marantz® SERVICE BULLETIN		Date: 16-Mar.-2004	Model: DV-12S2
		Page: 1 / 1	REF.NBR: MZ04-028
Circulation:		Application:	
x for information customer complaint in case of service mandatory		Only Lot number MZxxxxxx01xxxx	
		Subject: Can not set the PAL progressive mode.	
		Int.ref:

marantz® SERVICE BULLETIN		Date: 27-Feb.-2004	Model: DV-12S2
		Page: 1 / 1	REF.NBR: MZ04-018
Circulation:		Subject:	
Application:		Output signal distortion.	
x for information customer complaint in case of service mandatory			
		See Below

marantz® SERVICE BULLETIN		Date: 17-Mar.-2004	Model: SA-12S1
		Page: 1 / 1	REF.NBR: MZ04-030
Circulation:		Application:	
x for information customer complaint in case of service mandatory		See below	
		Subject: Can not playback specific DVD Disc.	
		Int.ref:

marantz® SERVICE BULLETIN		Date: 17-Mar.-2004	Model: SA-12S1
		Page: 1 / 1	REF.NBR: MZ04-029
Circulation:		Subject:	
Application:		Stop during Repeat playback mode.	
x for information customer complaint in case of service mandatory			
		See below

On the PA01-AUDIO CIRCUIT BOAD

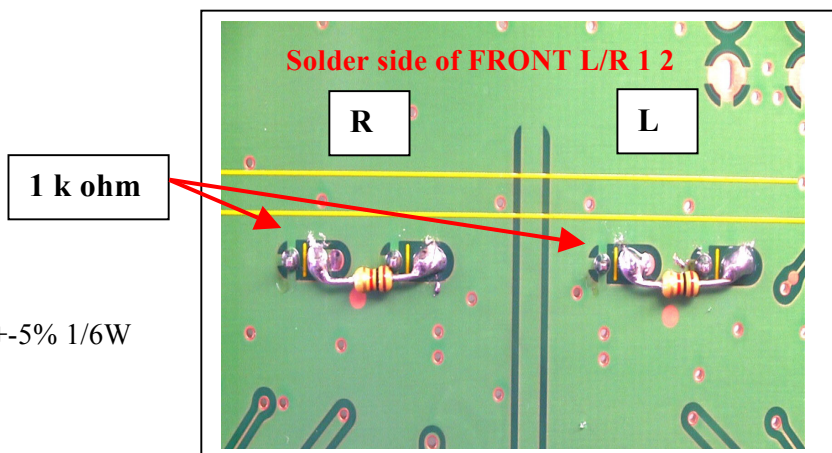
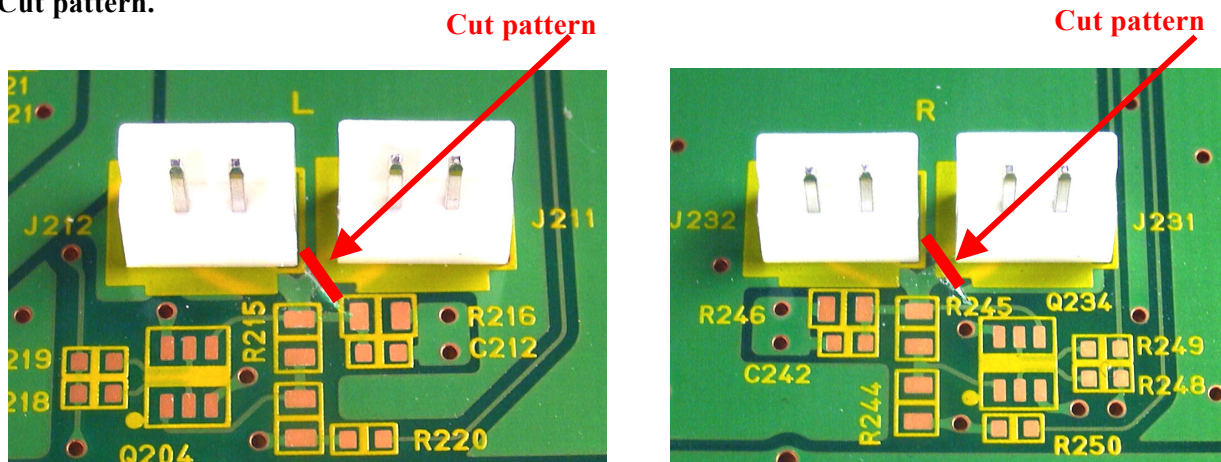
- 1) FRONT L/R 1 2 and SURR.L/R, CENTER L/R, SUB W L/R of AUDIO OUTPUT are simultaneously Connected to amplifier.
- 2) If the Amplifier which used the electronic switch is turned off, another sound will be distorted.

FRONT L/R 1 2 are connected parallel, therefore, if the Amplifier input of another side short-circuits, it will influence

1. Resistor 1k ohm is added to 2 of FRONT L/R 1 2.
2. Cut pattern.

Carbon film fixed resistor, 1k ohm +-5% 1/6W
(part no. GD05102160)

MONO (PZ01) CIRCUIT BOARD

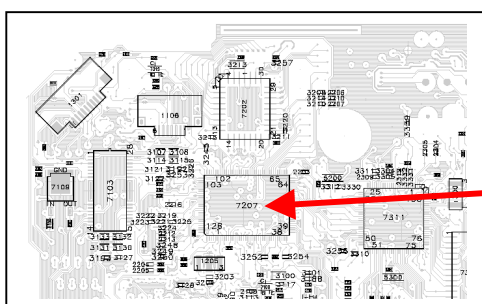
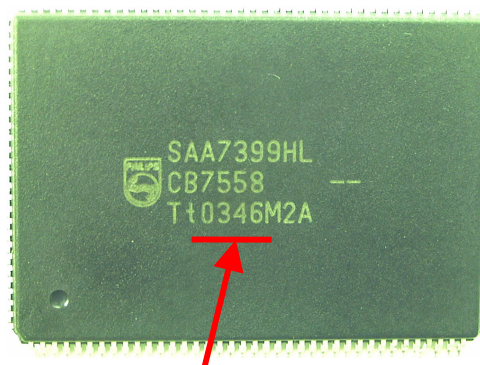
The part defect of Digital Servo Controller IC SAA7399HL.
(It occurs only in specific IC SAA7399HL up to week code 0346)

1) Replace IC SAA7399HL (7207) on the MONO (PZ01) CIRCUIT BOARD.

- 1) The part number isn't changed.
- 2) The distinction of fault and Improvement IC can be checked in week code on IC.
- 3) Fault is up to week code 0346. It has been improved from week code 0347.
- 4) Improved IC is delivered when IC is newly ordered to the MJI Spare parts center (ware house).

Fault is up to week code 0346.
It has been improved from week code 0347.
